GE Energy

MFN 07-221

Docket No. 52-010

**Subject: Response to Portion of NRC Request for Additional Information  
Letters, Nos. 77 and 90 – Safety Analysis – RAI Numbers 15.0-20  
through 15.0-23, 15.0-25 and 15.4-21**

Figure 15.0-20(A)-1 TBV Related Systems

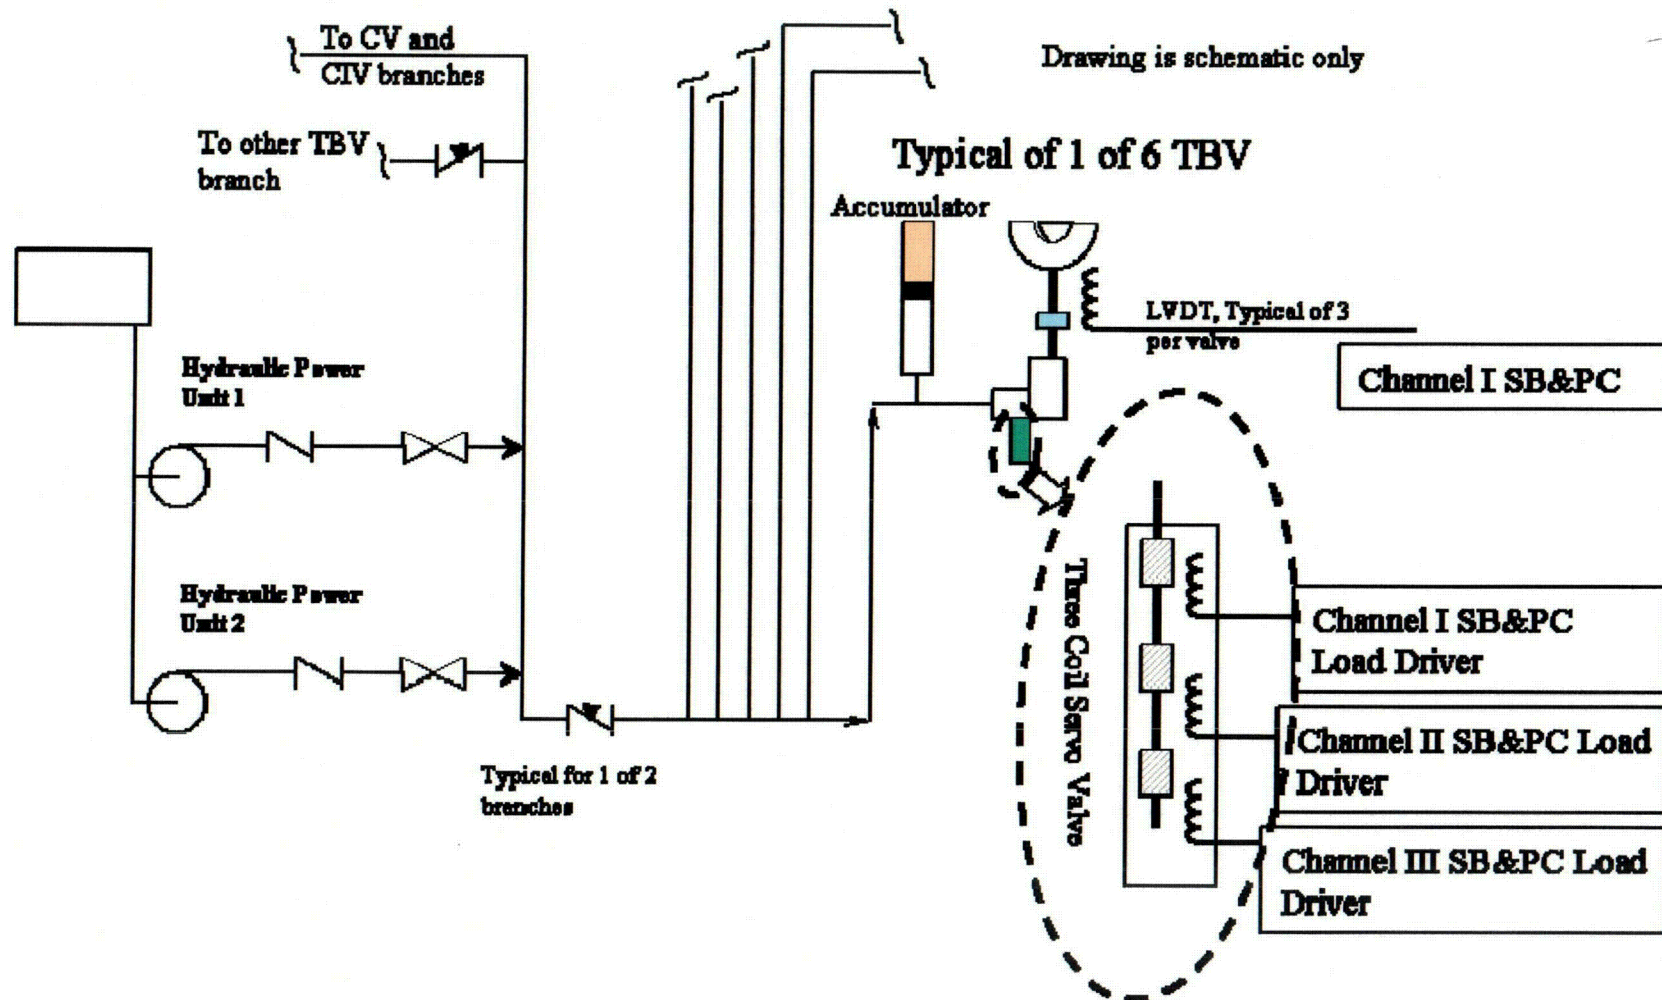
*(A) A simplified process flow diagram of the Turbine Bypass System and associated fault tree that models the failure of seven or more of the 12 available Turbine Bypass Valves (TBVs) on demand. This information should be readily available since it is part of the information needed to respond to RAI 19.1.0-55 of the PRA (basic event N21-SYS-FF-BYPASS). Please include discussion of assumptions made about the failure of TBVs and support systems (e.g., AC power, I&C, compressed air, and individual valve accumulators).*

Figure 15.0-20(A)-1 is a simplified schematic of the process flow diagram for the Turbine Bypass System (TBS).

The hydraulic system for the TBVs consists of the subsystems and components identified on Figure 15.0-20(A)-1. The critical items to note are the following:

Each TBV is independently controlled and has its own accumulator. (See Item (A) and RAI Figure 15.20(A)-1).

Figure 15.0-21-1 Loss of Feedwater Heating SCRRI & SRI

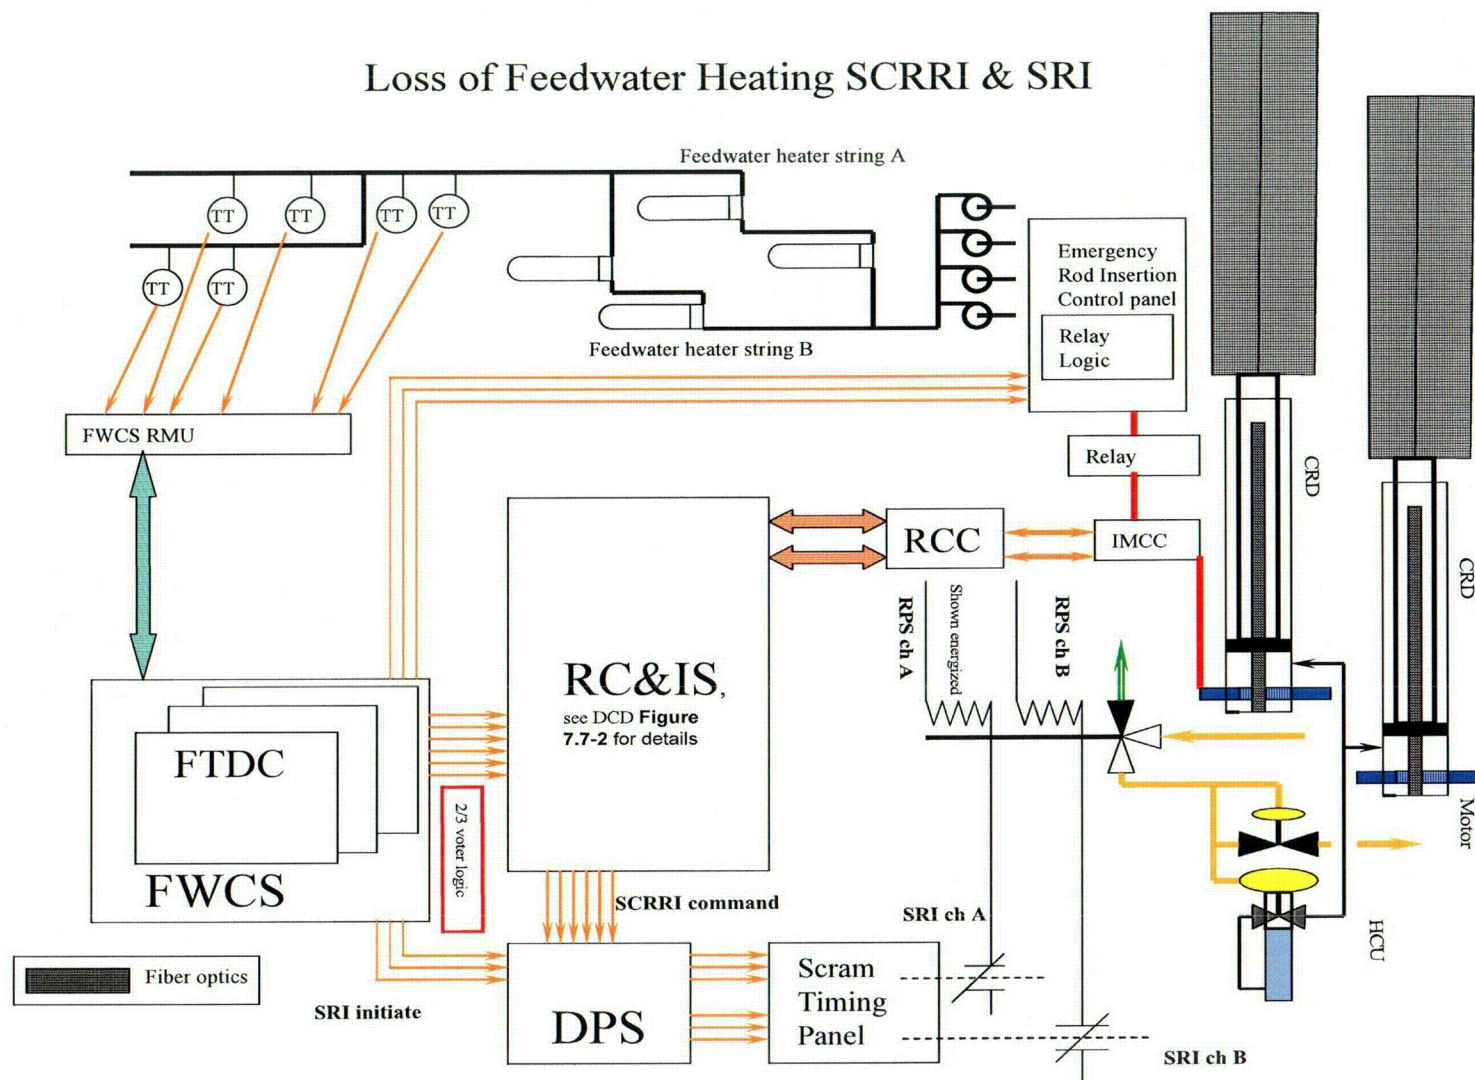
*(B) Additional information is needed for the staff to understand how the I&C systems were modeled in assessing the frequency of the "Loss of Feedwater Heating with Failure of Selected Control Rod Run-In" event. A simplified I&C block diagram, showing the processing of signals, important elements and design features (e.g., redundancy and diversity) and assumptions (e.g., independence and separation) for both automatic and manual actuation of components, would be very helpful. Such a simplified I&C block diagram could help answer staff questions, such as the following:*

A simplified I&C diagram for the loss of FW heating with failure of selected control rod run-in is shown in Figure 15.0-21-1.

B(1) The FWCS can be postulated to have a latent failure that defeats its ability to sense the loss of FW heating. This potential common cause failure is added to the failure modes assessed in the RAI response to 15.0-25(B).

B(2) The treatment of the primary and backup signals is included in the revised calculation presented in response to RAI 15.0-25(B). No operator action is required for the hard-wired signals.

**Figure 15.0-23(B)-1**  
**SRV Overpressurization**  
**(2 Pages)**

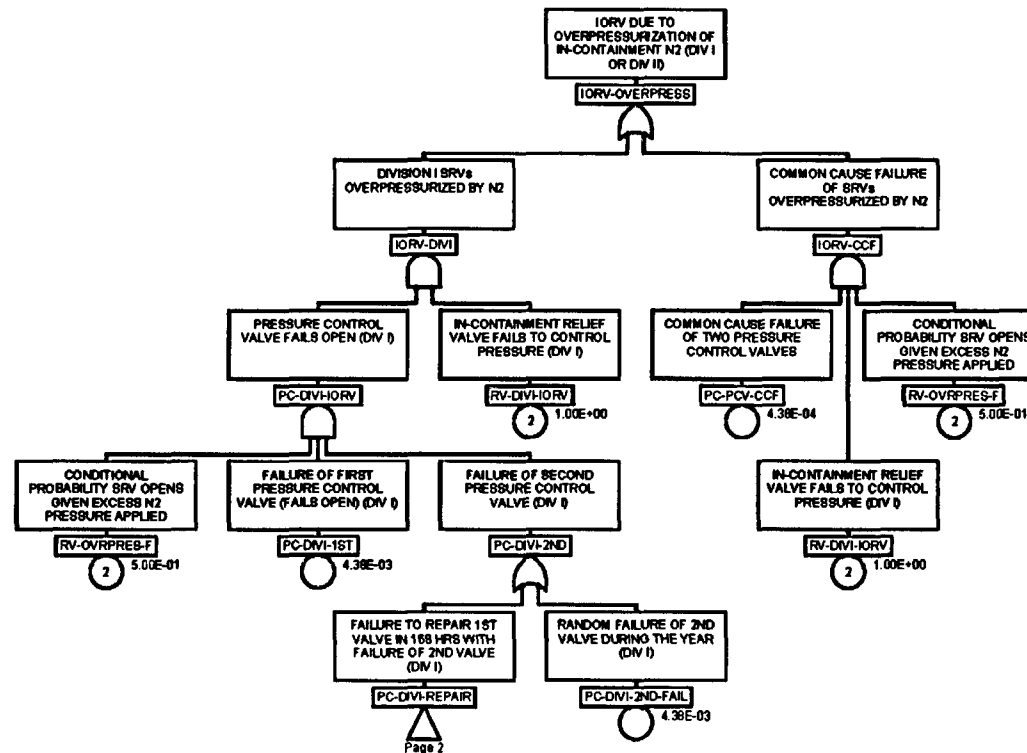
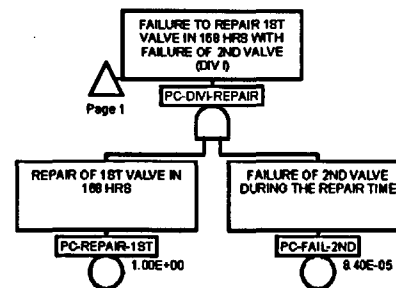
*(B) The probability of excess Nitrogen pressure leading to an IORV was estimated to be 1.5E-6 per year. This value is based on a proposed COL action item to confirm that no single failure in the nitrogen system can lead to IORV and the assumption of independence of failures. Please justify the assumption that no CCFs of the nitrogen supply system can lead to an IORV event. Otherwise assess the CCF contribution and revise the related probability. In addition, the assumed repair time of one week for a nitrogen supply system valve may not be a conservative value and needs to be justified in terms of requirements (e.g., Technical Specifications).*

Figure 15.0-23(B)-1 summarizes the failure modes that may lead to SRV overpressurization including common cause failures.

The revised total failure probability for SRV opening due to excess nitrogen pressure including the CCF is  $2.29\text{E-}04/\text{yr}$ .

Table 2.11.7-1

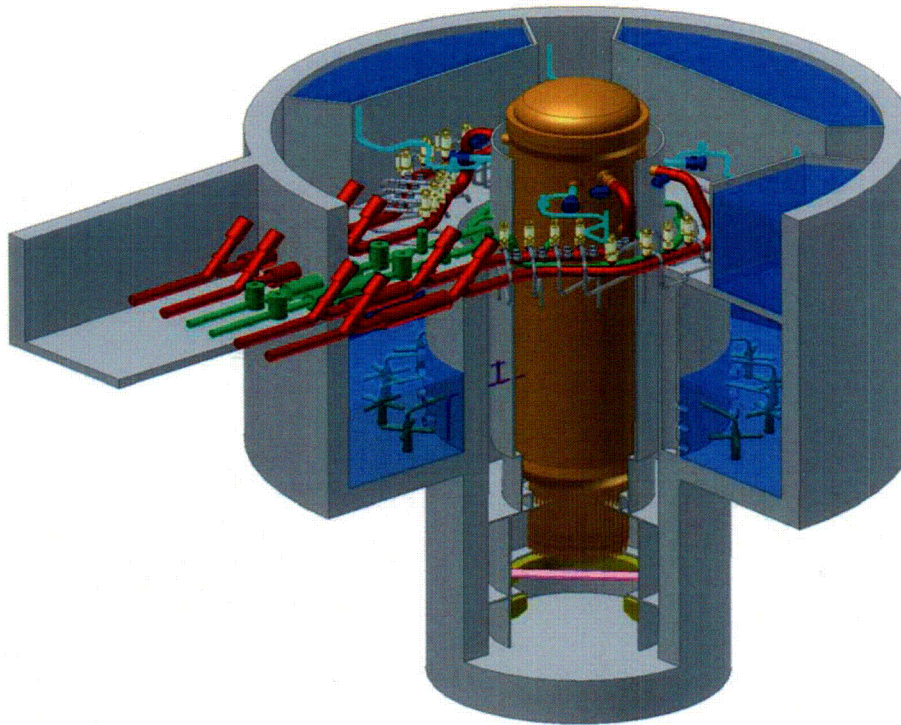
*Please explain the discrepancy. If necessary, revise the DCD, Tier 1, Section 2.11.7, "Main Condenser," under "Design Description" to include that the MC must also be analyzed to the SSE loading conditions.*

DCD Tier 1, Section 2.11.7, Design Description, will be revised to include condenser structural members in the statement regarding condenser integrity following a Safe Shutdown Earthquake. In addition, an ITAAC will be provided that corresponds to the above statement. Finally, DCD Tier 2, Section 10.4.1.1.1 will be revised to maintain consistency with DCD Tier 1. These changes are provided on the attached markups.

Design Commitment	Inspections, Tests, Analyses	Acceptance Criteria
1. The condenser <b>structural members</b> , supports, and anchors are designed to maintain condenser integrity following a safe shutdown earthquake.	1. An analysis of the ability of the as-built condenser <b>structural members</b> , supports, and anchors to maintain condenser integrity following a safe shutdown earthquake will be performed.	1. An analysis report exists which concludes that the as-built main condenser <b>structural members</b> , supports, and anchors are able to maintain condenser integrity following a safe shutdown earthquake.
